MORGAN AND MORECAMBE OFFSHORE WIND FARMS: TRANSMISSION ASSETS

Errata

Document Numbers:
MRCNS-J3303-RPS-19075
MOR001-CON-CAG-ASS-0005

Document Reference: S_D1_14/F02
Rev: F024

A.1 MCZ Assessment – Figure 1.7

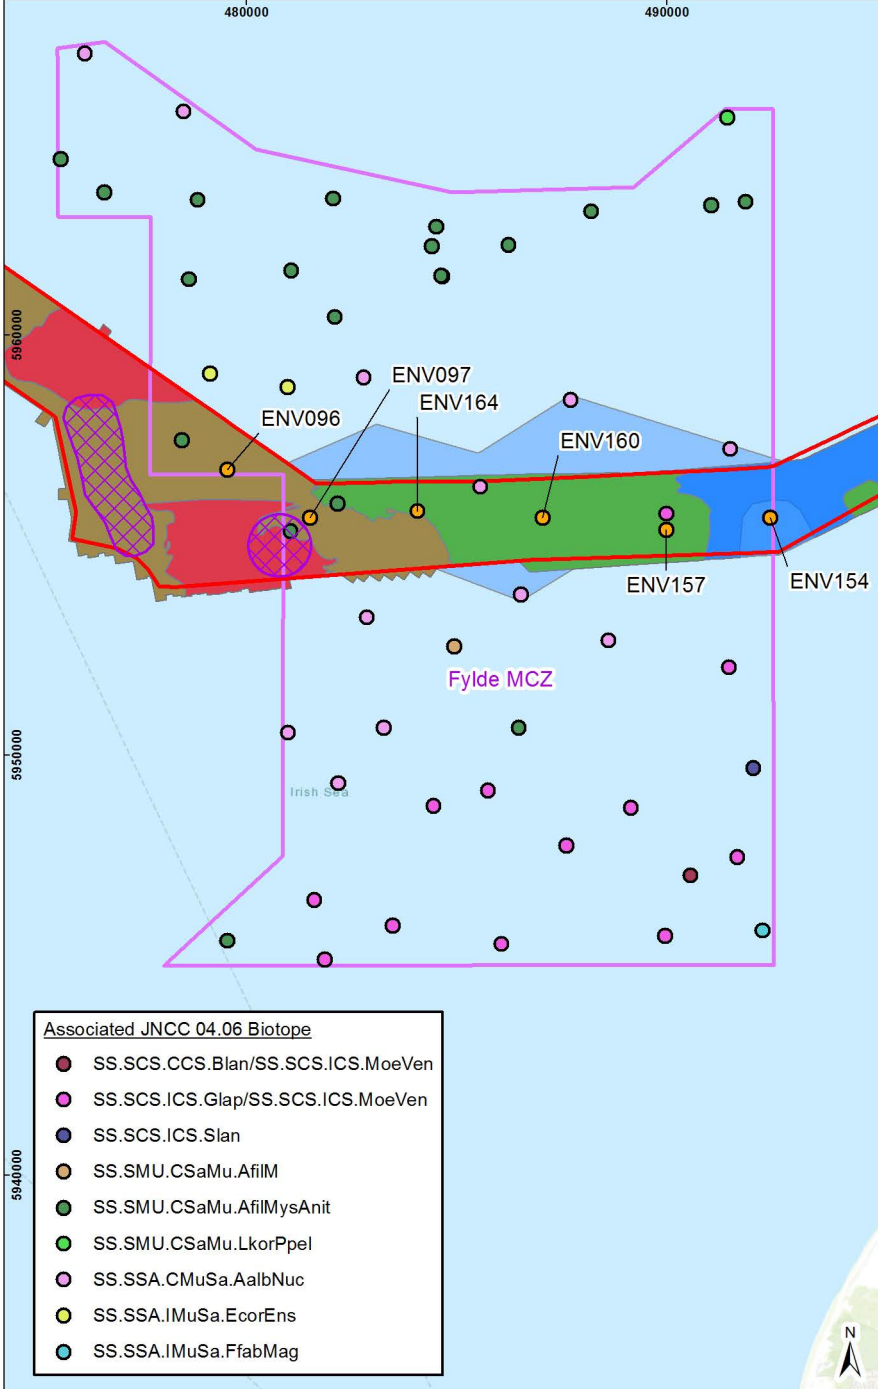
Errata document version	Document section	Description of errata
F01	Figure 1.7	The Applicants can confirm that the potential 'seapen and burrowing megafauna communities' IEF mapped in Figure 1.22 of Volume 2, Annex 2.1: Benthic subtidal and intertidal ecology technical report (APP-046) was erroneously missed from Figure 1.7 of the MCZ Screening and Stage 1 Assessment Report (APP-019). Figure 1.7 will be updated for has been updated for Examination at Deadline 2 (see Appendix A).
F01	Table 1.6	The Maximum design parameter for the Maximum total volume of cable protection (m ³), within MCZ (shown in the last row of the table) should be 30,400.
